Project Title: Land to the North of Arborfield Road

Project No/ Document Reference: HD008/TN007

PLANNING APPLICATION WBC 242484 / FLOOD RISK RESPONSE FOLLOWING ENVIRONMENT
AGENCY MODELLING COMMENTS

Figure 2: May 2026 Flood Modelling Results-Baseline

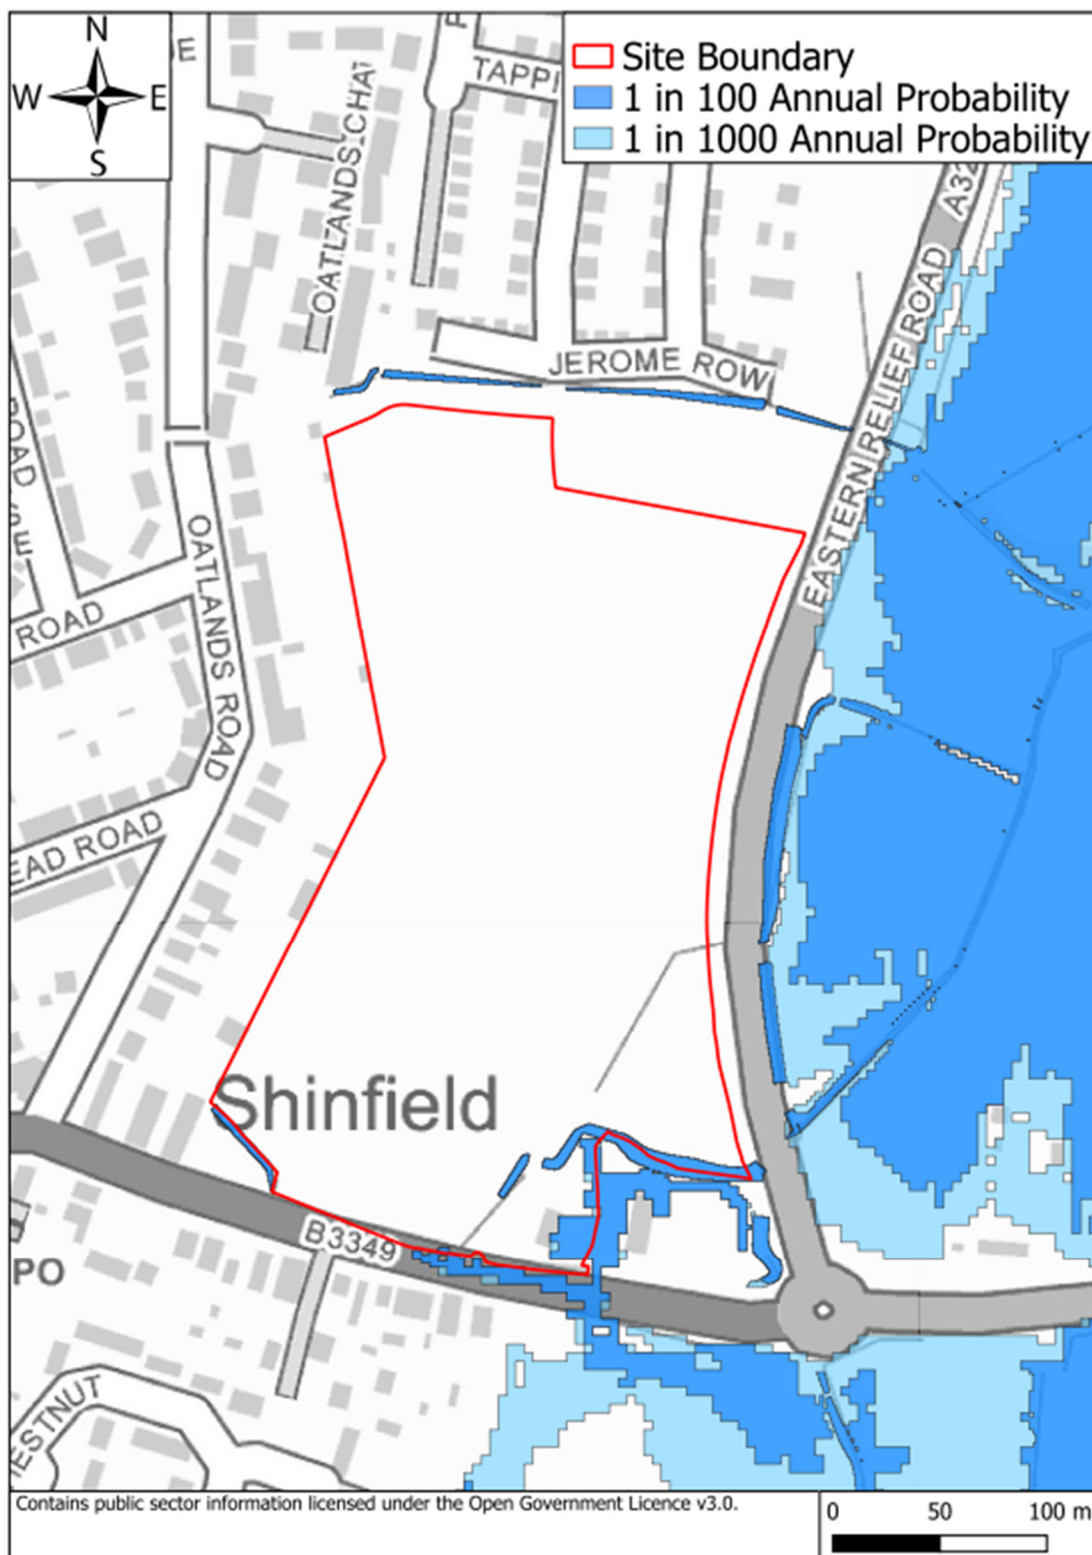
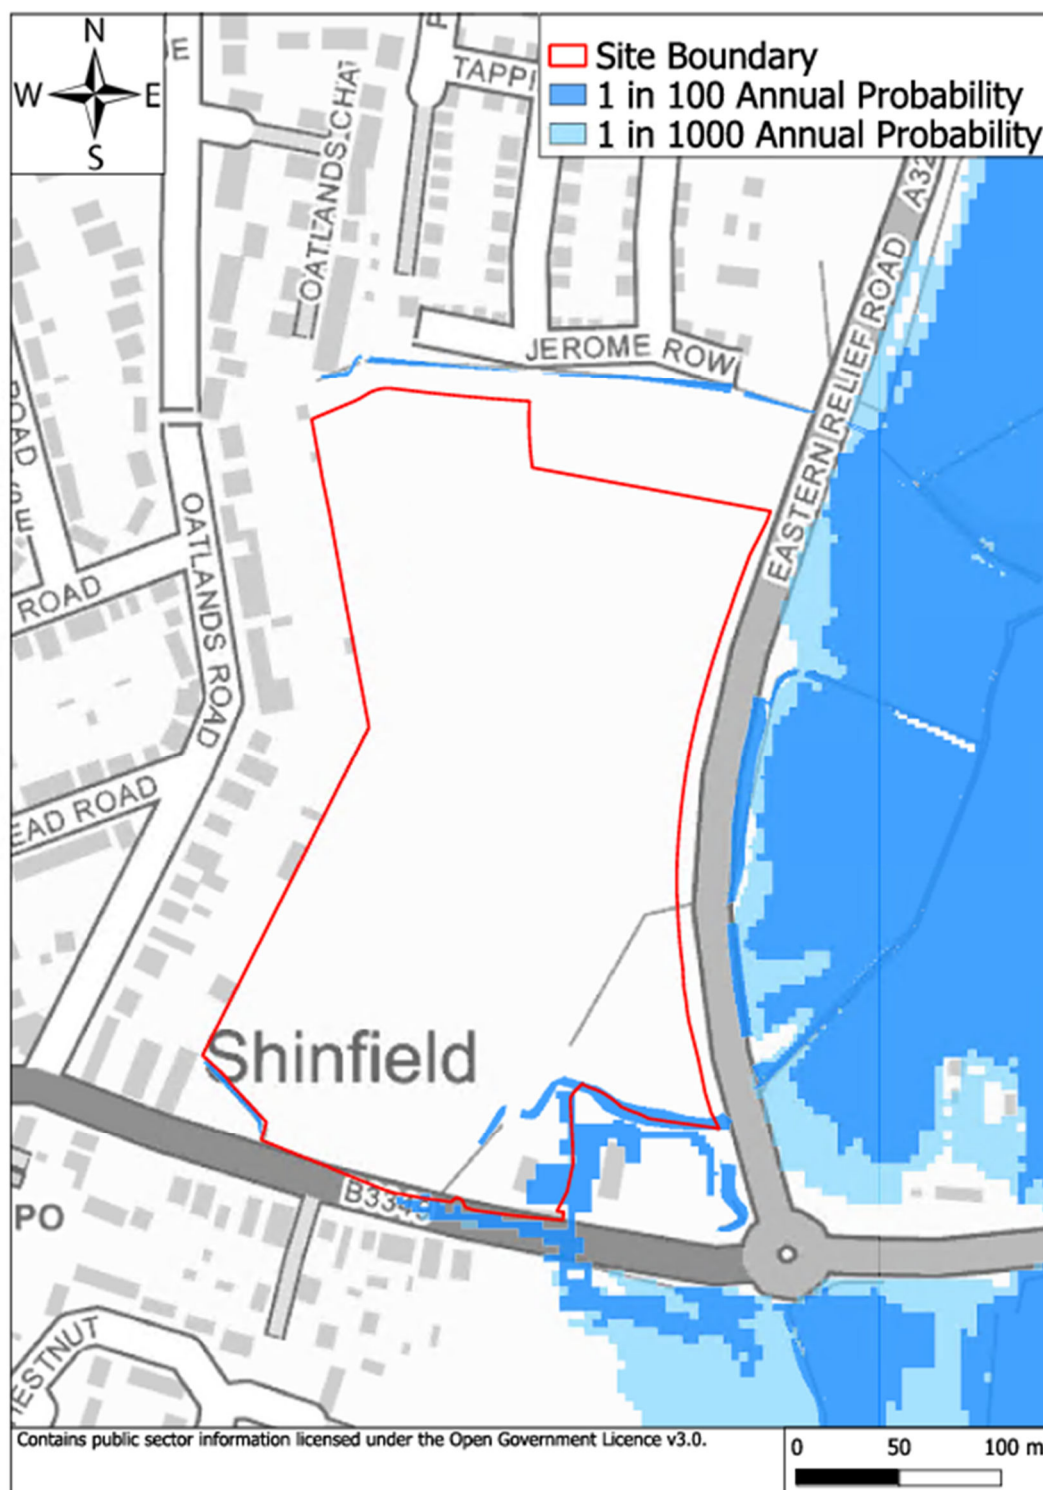
- 2.6. Enzygo has now completed further updates to the hydrological and hydraulic modelling in line with the EA comments of April 2026.
- 2.7. Enzygo has addressed the EA comments with the exception of the EA's comments on the flow inflow points for the tributary to the north of the site. The EA recommendation was to lump the total inflow for the watercourse at the upstream end of the tributary, but this would not be representative of the actual catchments for this watercourse. The Eastern Relief Road bisects the catchment and acts as a physical barrier for flow and it is therefore more accurate to treat this as two separate catchments. Indeed, were the flow to be lumped at the upstream end and then throttled by the structures at the Eastern Relief Road this could lead to an underestimation of the flows within the downstream reaches of the tributary and affecting the Loddon floodplain extent. This is explained fully in Enzygo's report: Hydrological Assessment – River Loddon, Watercourse 1 and 2, ref SHF.1154.040.HY.R.003.C in section 2.5 and 2.6. The current approach is deemed most appropriate for this catchment and, furthermore, was previously approved by the EA.

- 2.8. The updates to the modelling have resulted in some changes to the floodplain extents and depths shown from the modelling for both the River Loddon and its tributaries.

2.10. **Figure 2** shows the results of the current modelling completed in May 2026 for the 1 in 100 and 1 in 1,000 annual probability events.

- 2.11. This shows little change to the flood extent shown within the site.
- 2.12. **Figures 3 and 4** show the modelled flood extents overlaid on the final masterplan for the 1 in 100 and 1 in 1,000 annual probability events (to compare to **Figure 2**) and for the design event, the 1 in 100 annual probability event with 14% climate change uplift.
